Re: APP/19/00623
46 Warblington Road, Emsworth, PO10 7HE

I am writing to you to comment on the above planning application.

MAP2.

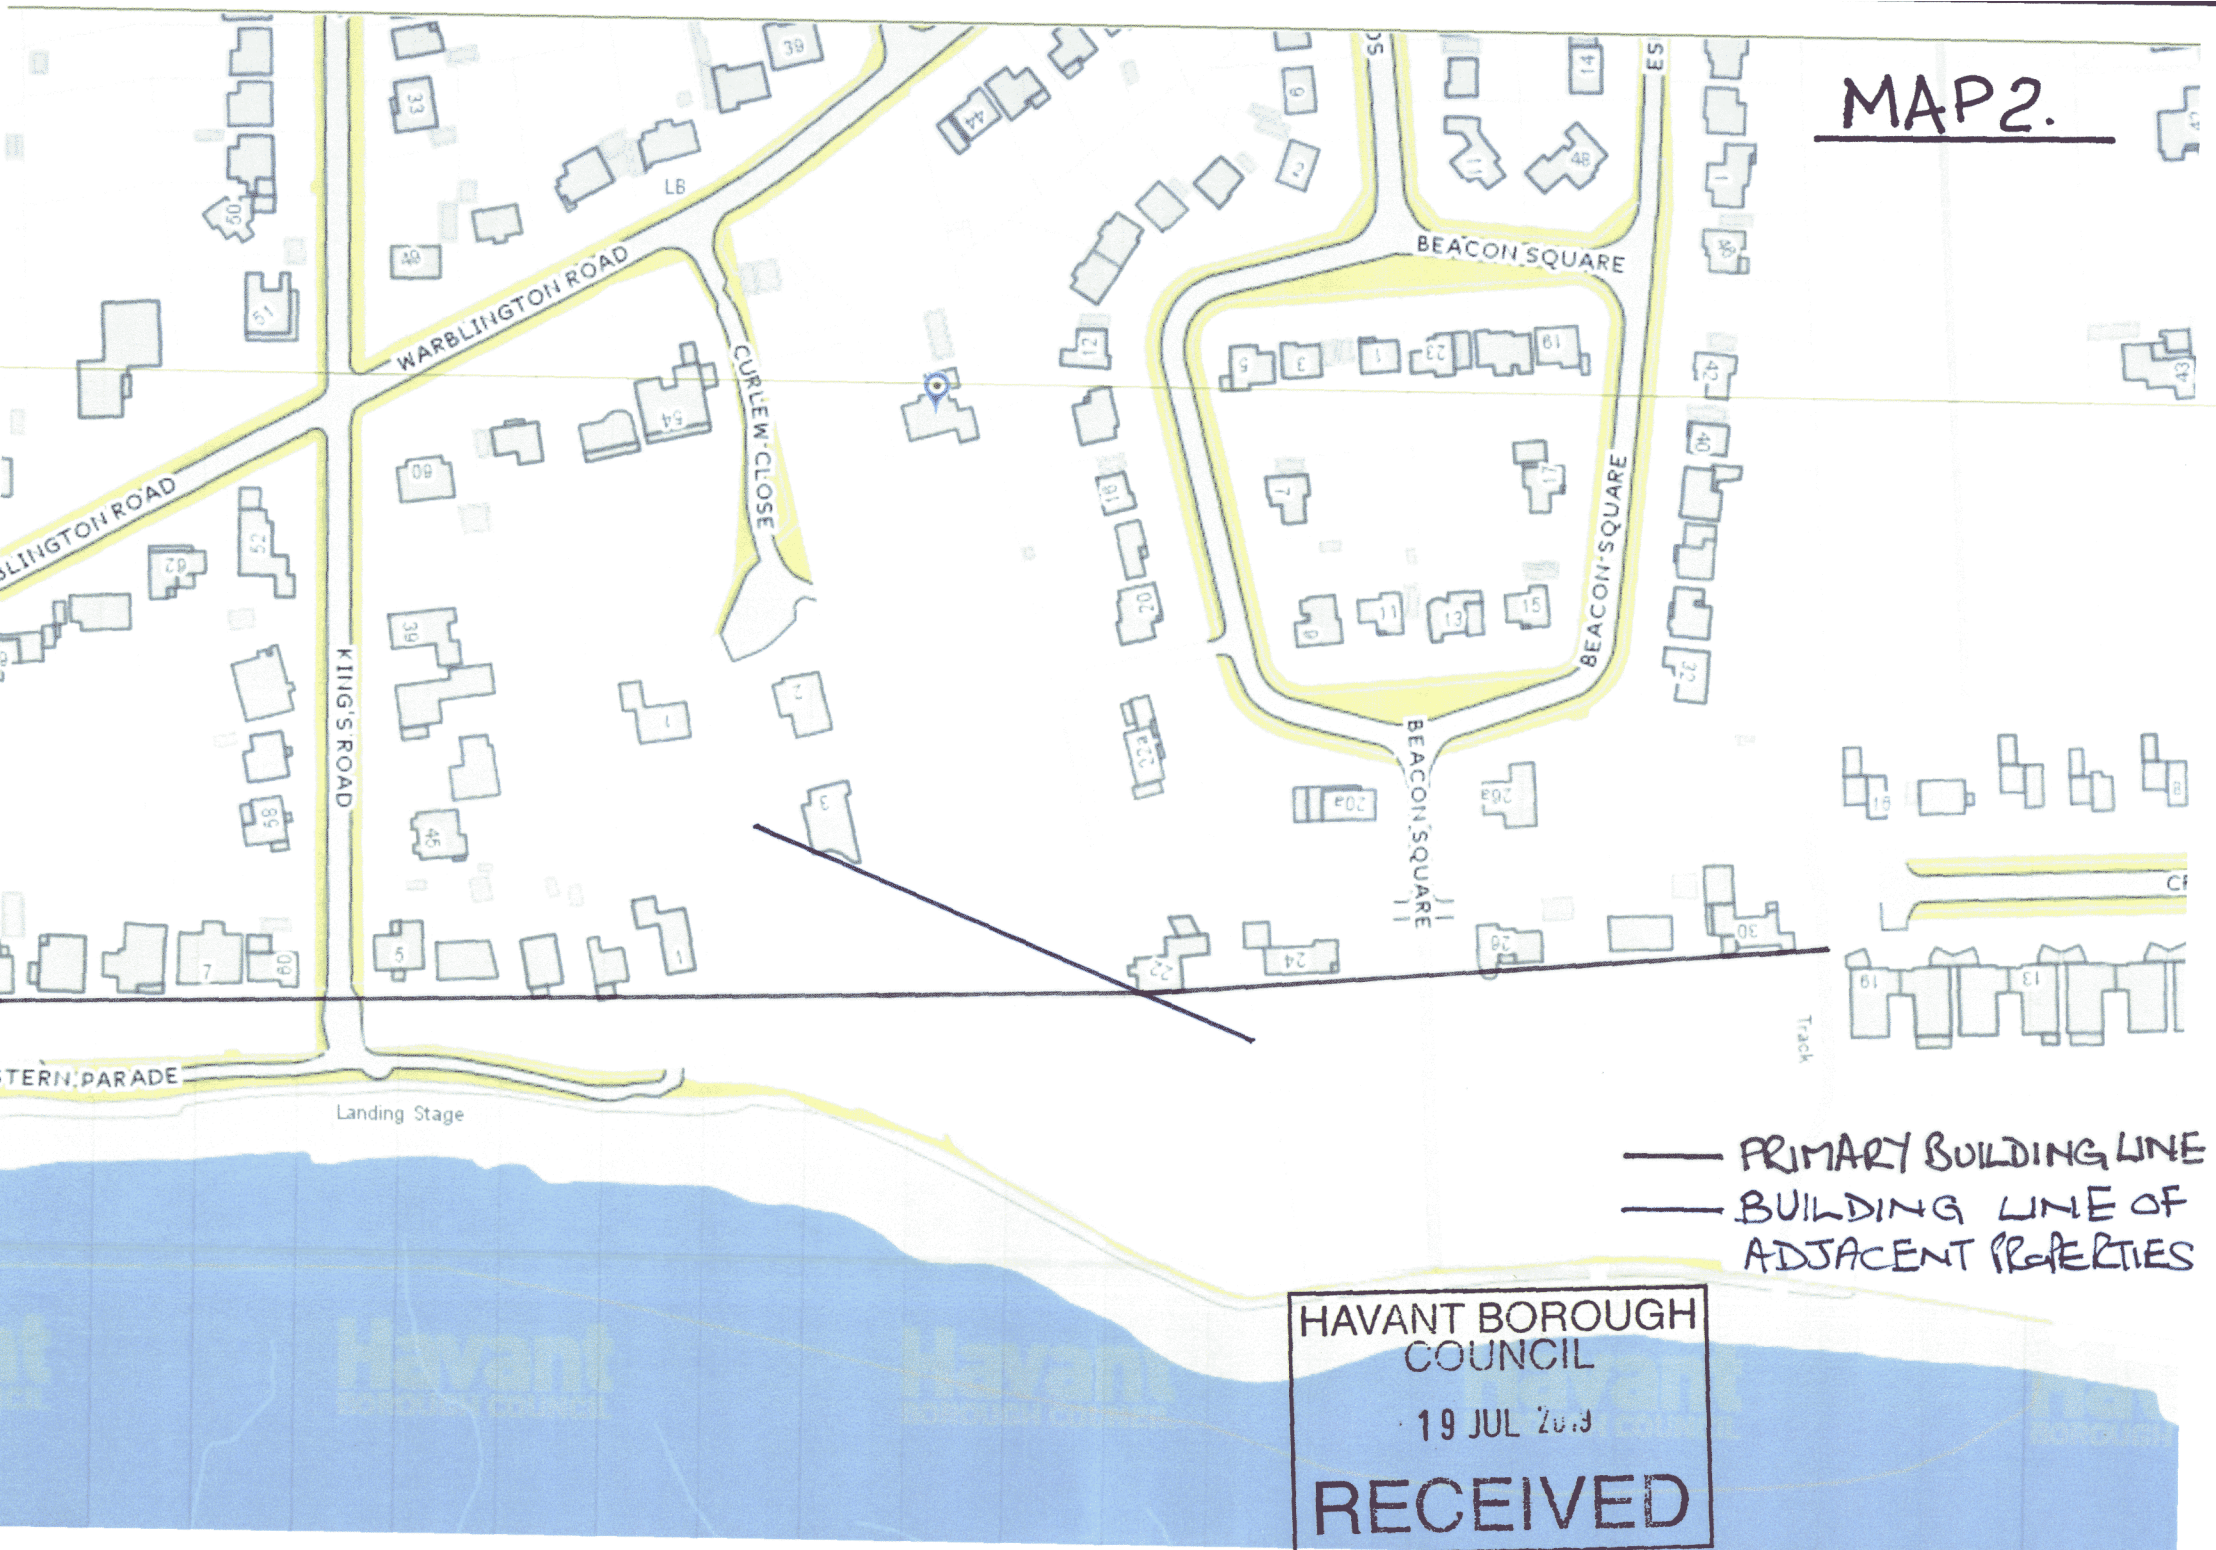
There is a strong case here for using a building line derived from the adjacent property dwellings. This is because it is a natural line that is parallel to the line of the shore in this immediate vicinity, shown in blue on the enclosed Map 2.

In any event, no part of any dwelling within this development should encroach beyond the strong primary building line shown in red on the enclosed Map 2.

MAP 1.

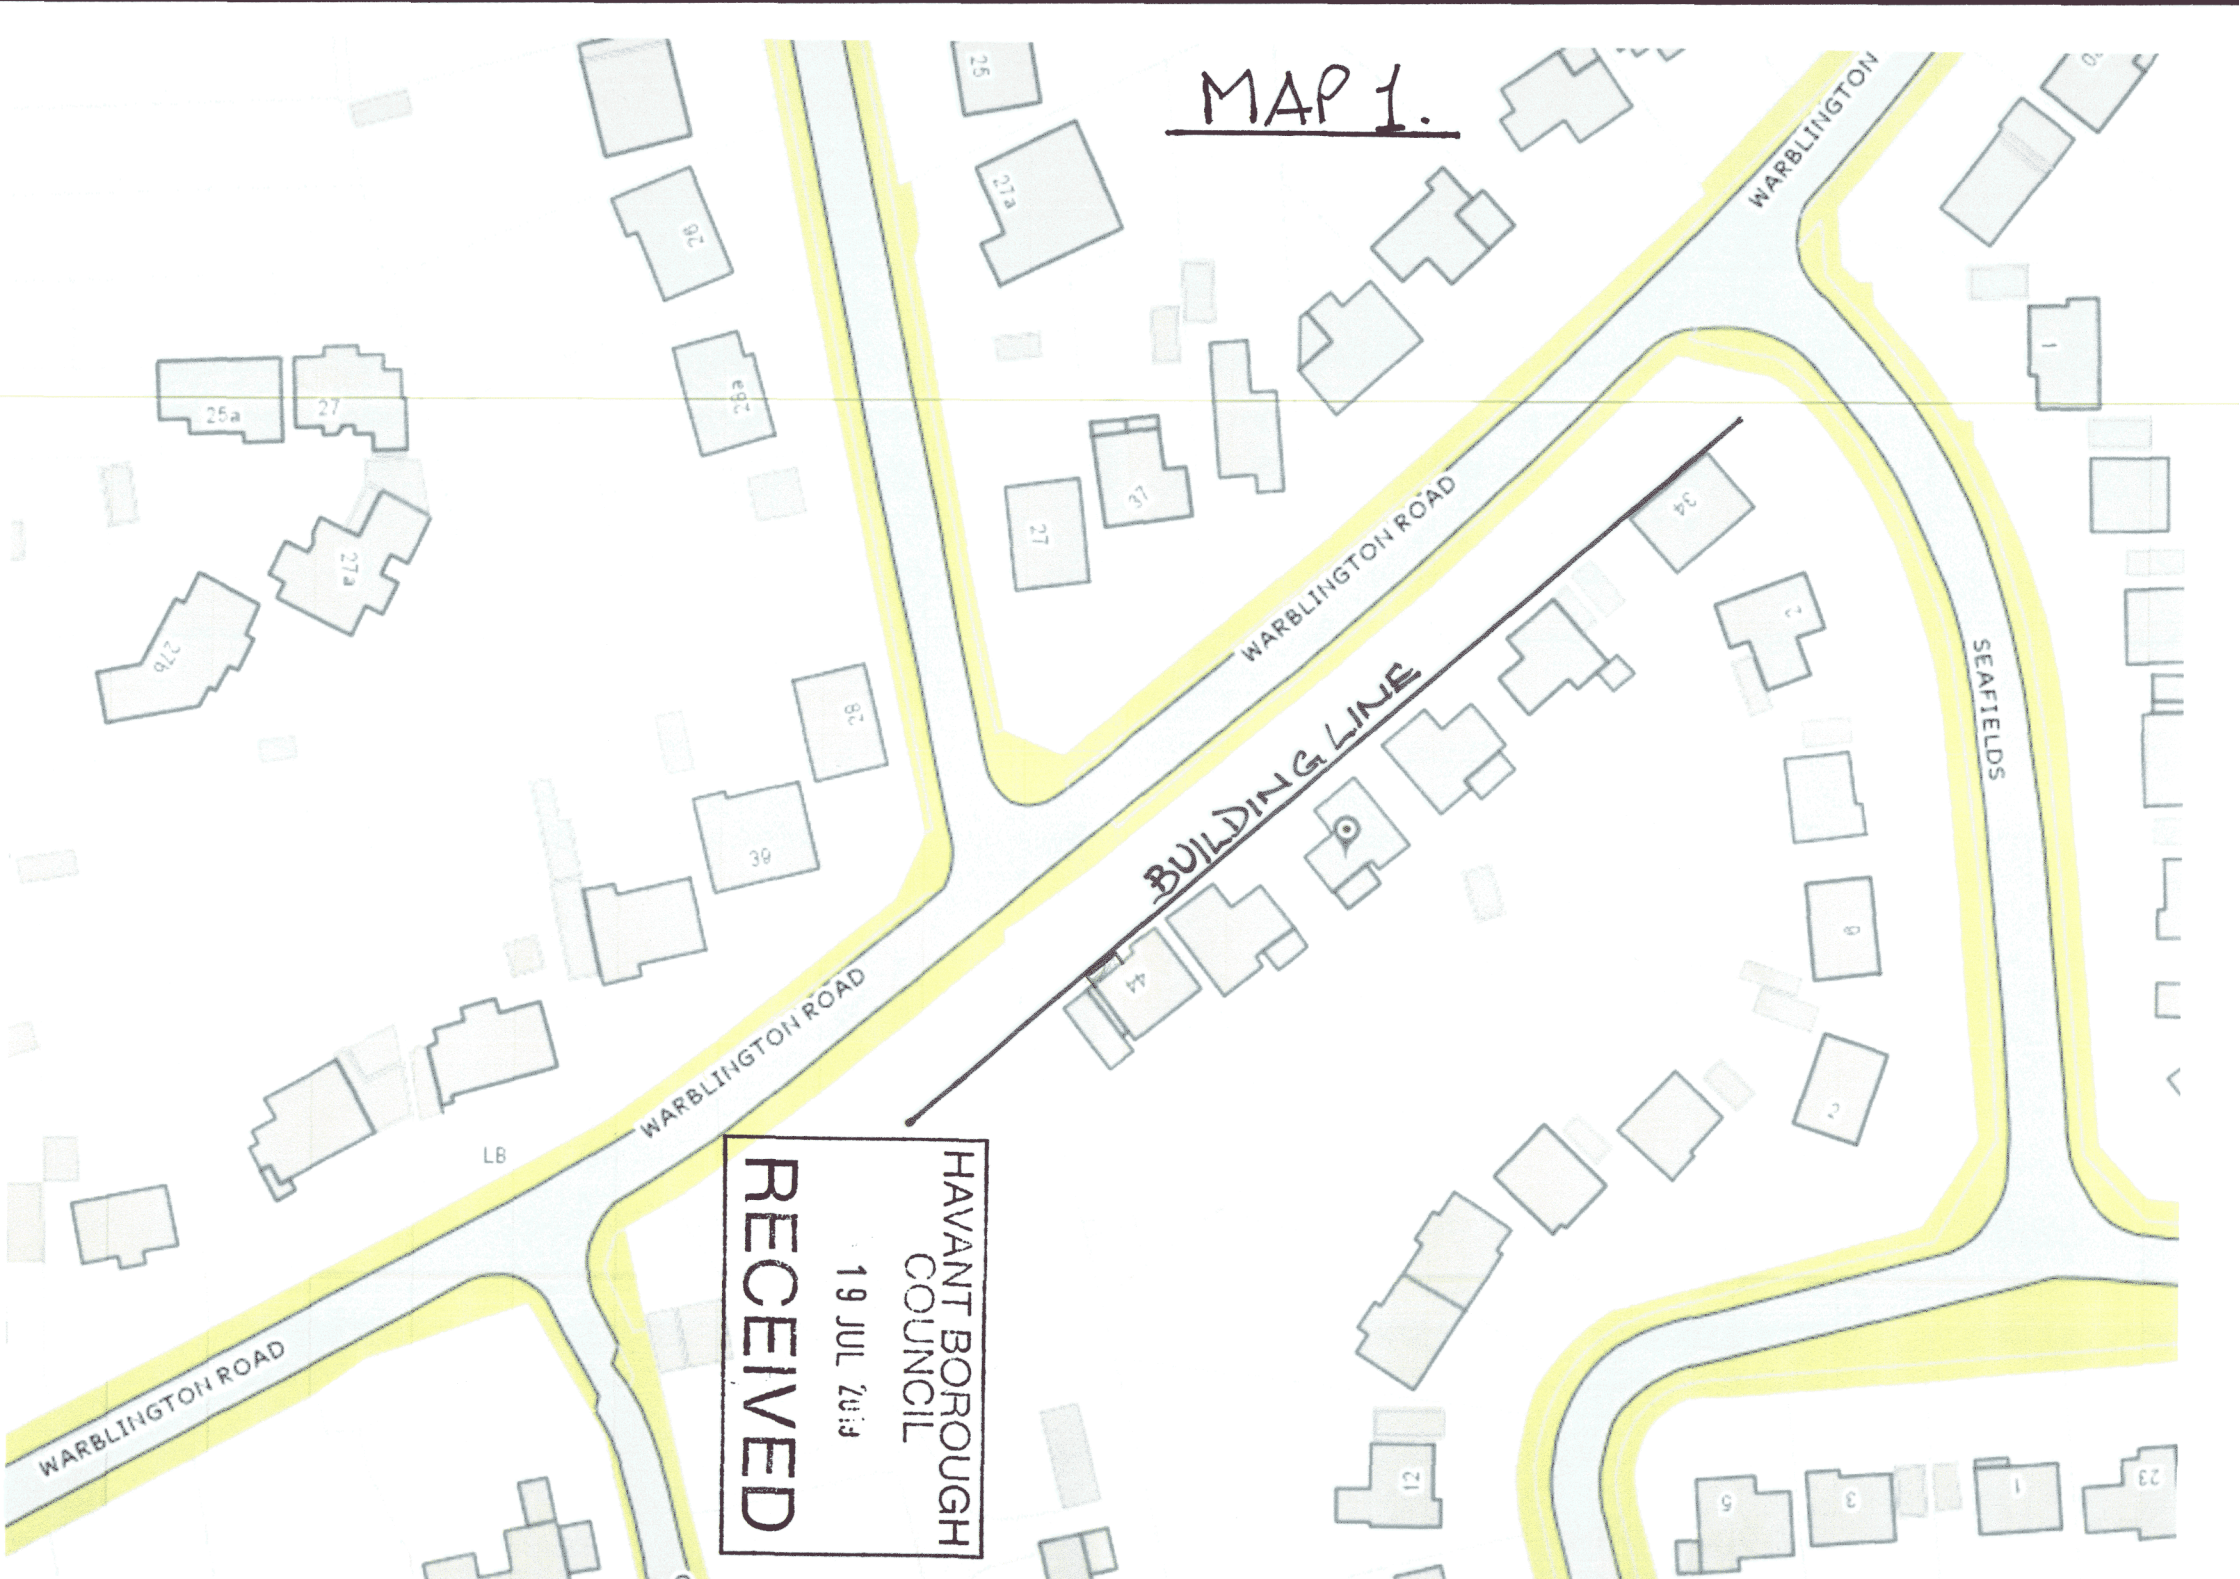
To comply with the above stated Havant Planning policies, dwelling Unit 5 should consequently be set back to that building line and, furthermore, its orientation should be parallel to Warblington Road rather than to the proposed new access driveway.

The building line is shown in red on the enclosed Map 1.

The Design and Access Statement submitted with this Planning Application shows (under 5 / Policy Statement) that Dwelling Unit 5 is significantly forward of the strong building line established by the immediate neighbouring properties numbered 34 to 44 Warblington Road. This building line allows for the local forward extension to 44 Warblington Road, already approved by Havant Planning.
